Request for Additional Information No. 240 (2800), Supplement 1, Revision 0

U. S. EPR Standard Design Certification

Docket No. 52-020

SRP Section: 18 - Human Factors Engineering

Figure 18.1-2—HFE Design Control Process

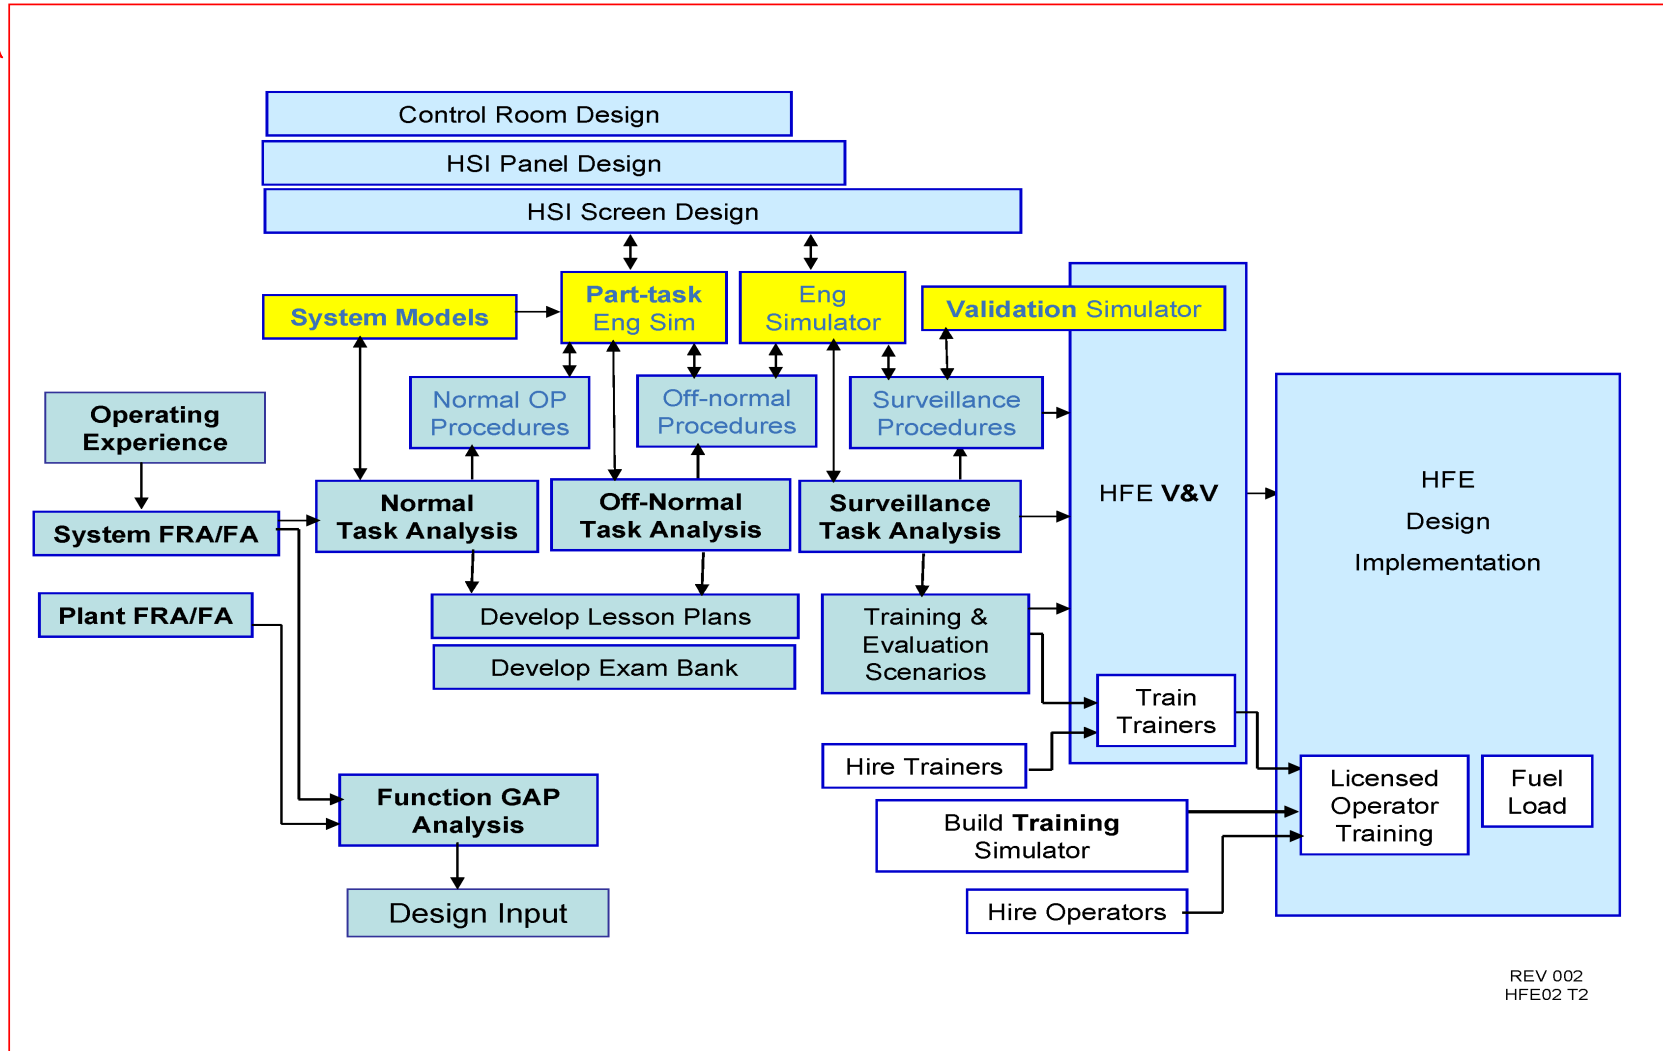
The ~~background shading in Figure 18.1-2 illustrates how the~~ U.S. EPR design occurs in four design phases. The milestone schedule shown in Figure 18.1-1 is developed with an understanding of the relationship between design phases.
